Access Compliance Report

Public Rights-of-Way

(Curb Ramps)

Intersection ID: 27432	Main Street: BALLANTYNE_COMMONS_PY	Cross Street: DURANT_BV	Location: NE
ADA ID: E6AFB1A1A53F	Ramp Type: BlendTrans1	Initial Pass/Fail: Fail	Overall Compliance: No
Severity Score: 25			
Codes/Mitigation Info/Possible Solution		Field Measurements/Component Compliance

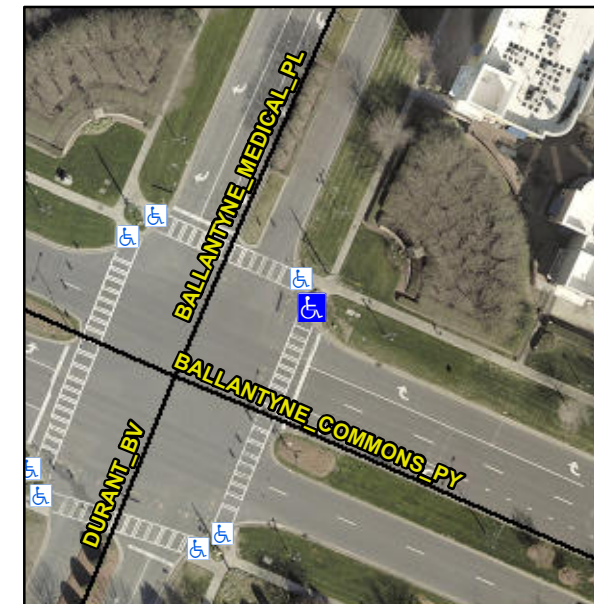
Not Found, R304.5.3

Compliance	Description	Data	Compliance	Description	Data
N/A	Ramp Length (in)	148.0	Yes	BlendTrans Slope (%)	0.8
Yes	Ramp Width (in)	48.0	No	BlendTrans XSlope (%)	11.7
N/A	Flare Type LT	N/A	N/A	Flare Type RT	N/A
N/A	Flare Slope LT (%)	N/A	N/A	Flare Slope RT (%)	N/A
N/A	Flare Traversable LT?	N/A	N/A	Flare Traversable RT?	N/A
N/A	Landing Length (in)	N/A	N/A	DWS Provided?	N/A
N/A	Landing Width (in)	N/A	N/A	DWS Contrast?	N/A
N/A	Landing Slope (%)	N/A	N/A	DWS Length (in)	N/A
N/A	Landing X Slope (%)	N/A	N/A	DWS Full Width?	N/A
N/A	Landing Curb? (Y/N)	N/A	N/A	DWS Offset (in)	N/A
N/A	Shared Landing?	N/A			
N/A	Gutter Ponding?	N/A	N/A	Gutter Slope (%)	N/A
N/A	Gutter Lip Ht (in)	N/A	N/A	Gutter X Slope (%)	N/A
N/A	Painted X Walk1?	Yes	N/A	Painted X Walk2?	N/A
	X Walk 1 Direction	To SW		X Walk 2 Direction	N/A
	X Walk 1 Width (in)	120.0		X Walk 2 Width (in)	N/A
	X Walk 1 Slope (%)	7.4		X Walk 2 Slope (%)	N/A
	X Walk 1 X Slope (%)	6.3		X Walk 2 X Slope (%)	N/A

N/A	Ramp inside XWalk1?	Yes	N/A	Ramp inside XWalk2?	N/A
	Road Slope (%)	6.3		Clear Space?	N/A
	Road X Slope (%)	7.4	N/A	Clear Space to XWalk (in)	N/A
N/A	Any Obstructions?	N/A	N/A	Storm Grate/Utility Hazard?	N/A
	Obstruction Type			Storm Grate/Utility Type	
		N/A			N/A
			Yes	Surface Condition? (G/P)	Good
			No	Curb Slope (%)	24.4

Remove & Replace Curb Ramp With Two New Directional Ramps or Equivalent.
